1984 Corvette: Service Bulletin: Side Door Lateral Movement

Subject: Side Door Lateral Movement

Model Year: 1984 Corvette

Bulletin No: 84-118, Section: 10 (I)

FIGURE 1

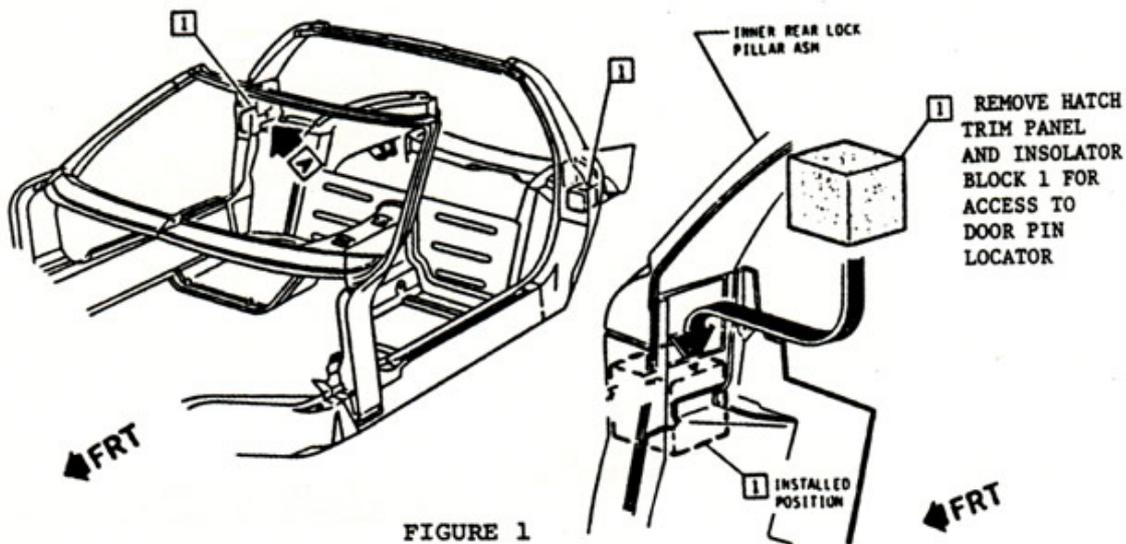
Verify the plastic sleeve is installed in the pin locator assembly. With the vehicle door closed, loosen the locator three (3) attaching bolts (see Figure 1). The locator assembly is to be centered fore-aft and vertically on the door pin. Push the locator outboard to fully engage the door pin and tighten the locator attaching bolts to 11 N.m (8 ft. lbs.)

FIGURE 2

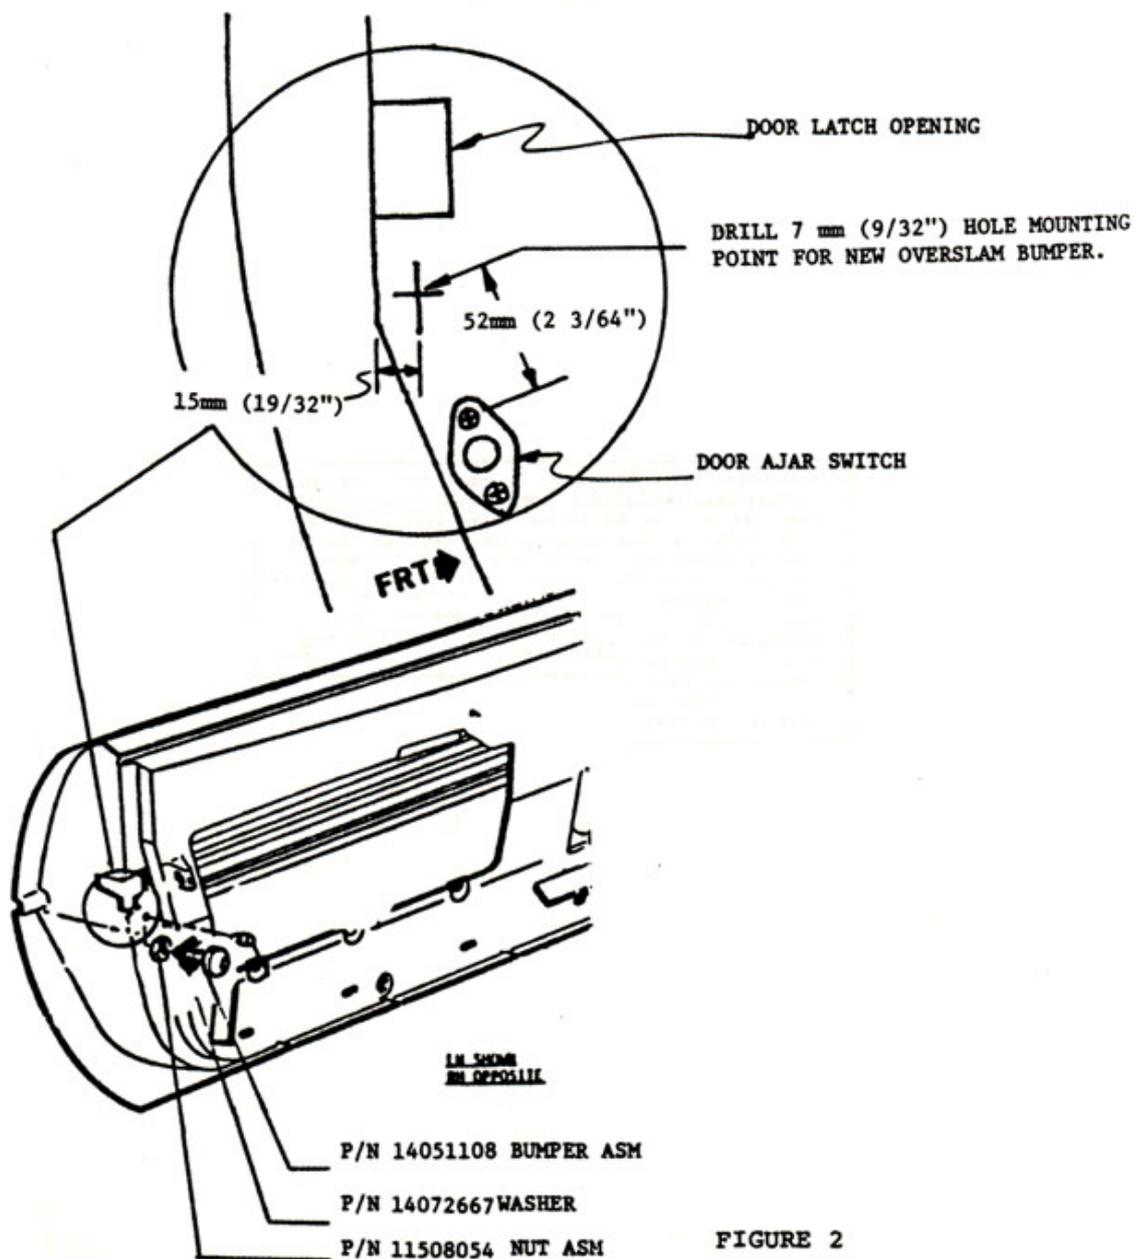
Some early built vehicles did not have overslam bumpers. if this is the case, it will be necessary to drill a 7mm (9/32") hole in the door (see Figure 2).

Add shims (washers) between bumper and door, as required, to eliminate lateral door movement (see Figure 2). DO NOT "OVERSHIM" BUMPER.

Replace the discarded production bumper(s) with bumper, P/N 14051108, attaching nut, P/N 11508276, and P/N 14072667, flat washers, which are to be used as bumper shims. The number of shims required will vary form vehicle to vehicle depending on "Build stacks".

Once shim pack has been established, tighten bumper retaining nut to 12 N.m (9 ft. lbs.) and check the door ajar lamp for proper operation. The door ajar switch is self-adjusting and cannot be reset.
